SUBJECT: ADMINISTRATION AND EARLY LEARNING CENTER ADDITIONS
ORCHARD FARM R-V SCHOOL DISTRICT
ST. CHARLES, MISSOURI
PROJECT # 23-09C

ORCHARD FARM R-V SCHOOL DISTRICT
ADMINISTRATION AND OFFICE ADDITIONS
ST. CHARLES, MISSOURI

JULY 23, 2024

The drawings and specifications are hereby supplemented and amended to include the following particulars:

C7.00
SD-4

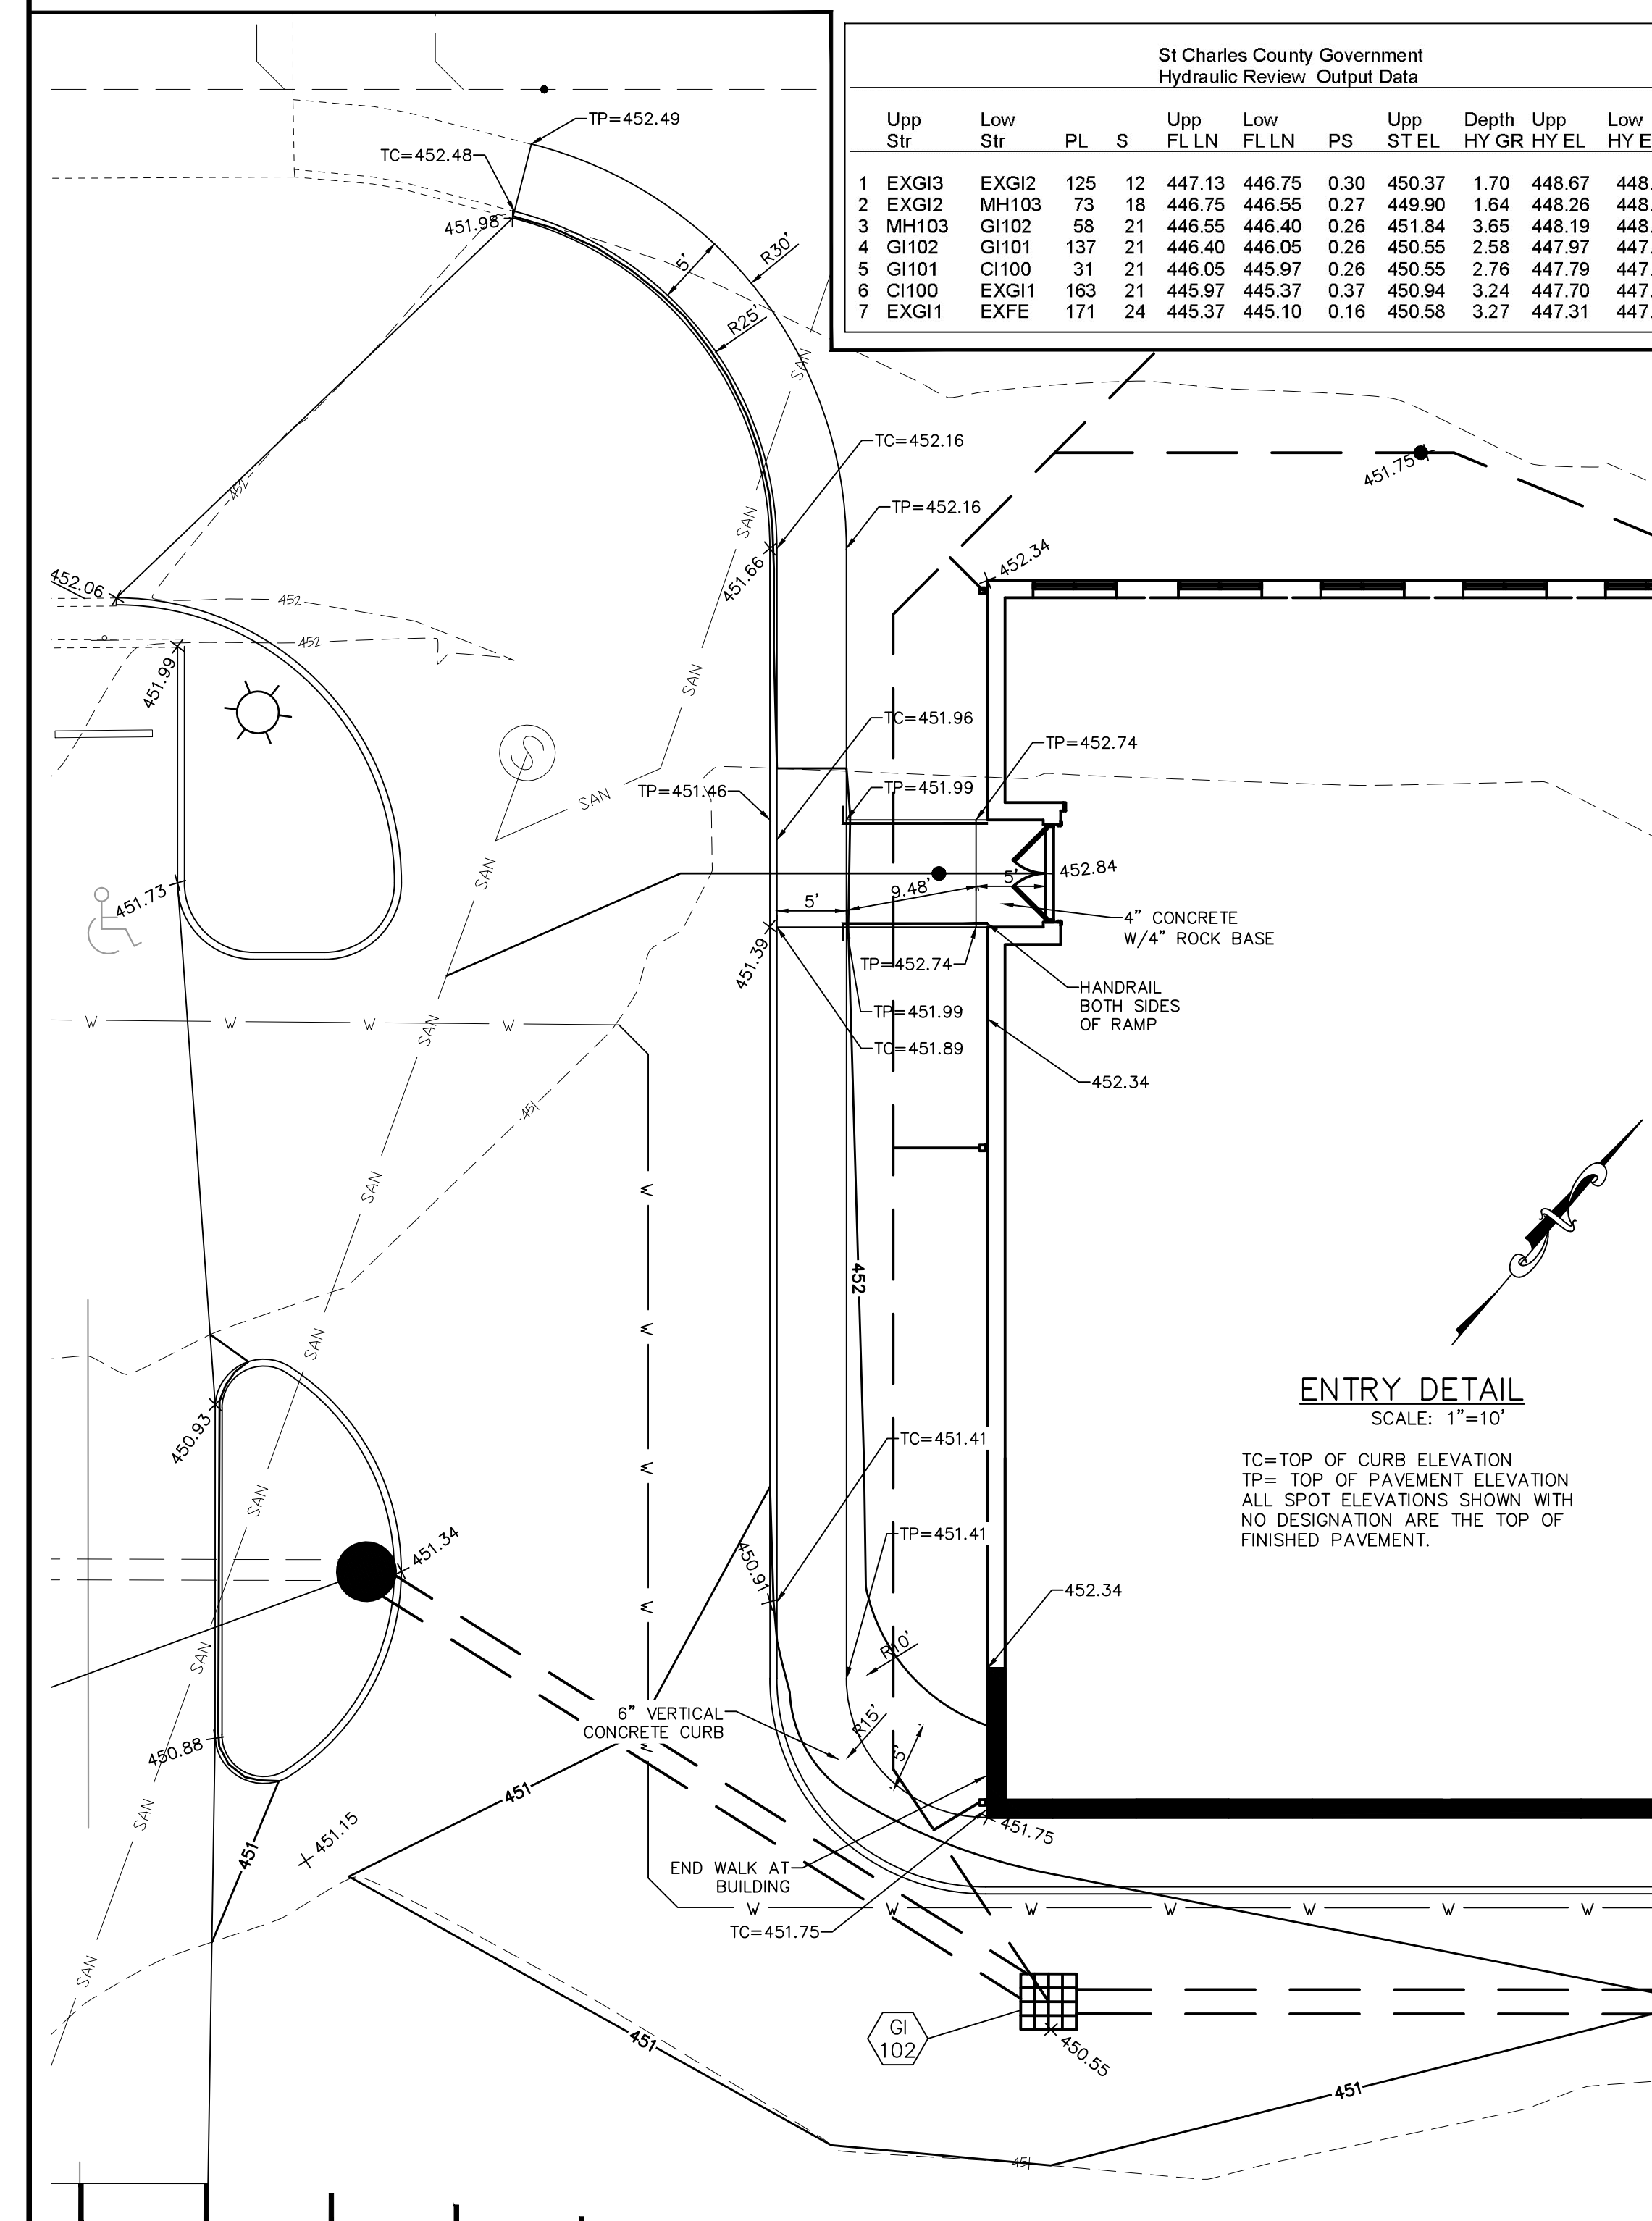
ITEM NO. 3: CIVIL DRAWING C7.00

- A. **“ADD”** Supplementary Drawing No. SD 4, dated July 23, 2024 included with this Addendum, and hereby made a part of the Contract Documents that shows added to pavement remediation detail.
